FIELD REPORT – LYNNWOOD RECREATION CENTER – FIELD REPORT

REPORT #01

Job No. 10-100622B1

Location(s) of Work: Natatorium roof.

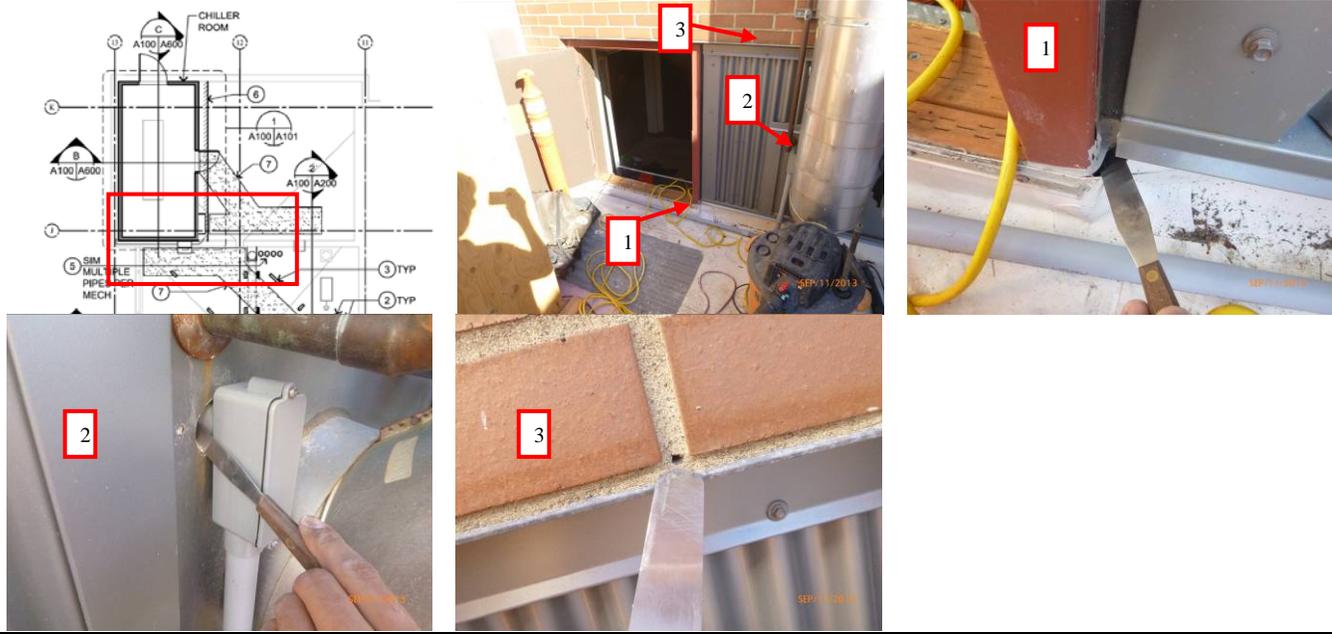
1.4 At concrete curbs, no sealant is observed behind the baseflashing termination.

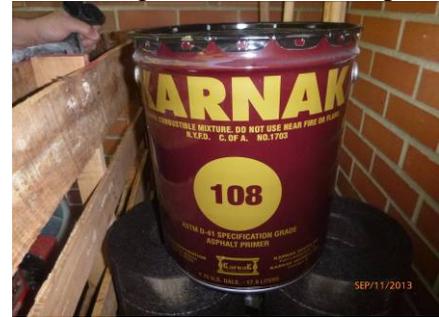
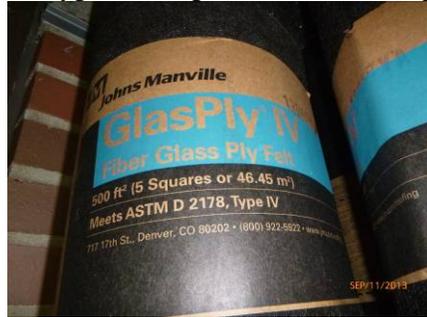
- 1.8 Holmberg is demolishing the concrete curb at the east side of the Natatorium Roof. Per conversation with Holmberg, the existing openings are to be infilled with self-leveling grout or ledgers and plywood. Recommend that the curb demo is sequenced with the Roofing Contractor to prevent damage to the new vapor retarder layer. Also recommend that any deformities or voids created during or due to the curb demolition are smoothed down and/ or infilled to provide a smooth substrate for the new roofing.

- 1.12 At the concrete curb to the east it is recommend that the substrate be corrected prior to the installation of the new vapor retarder layer.
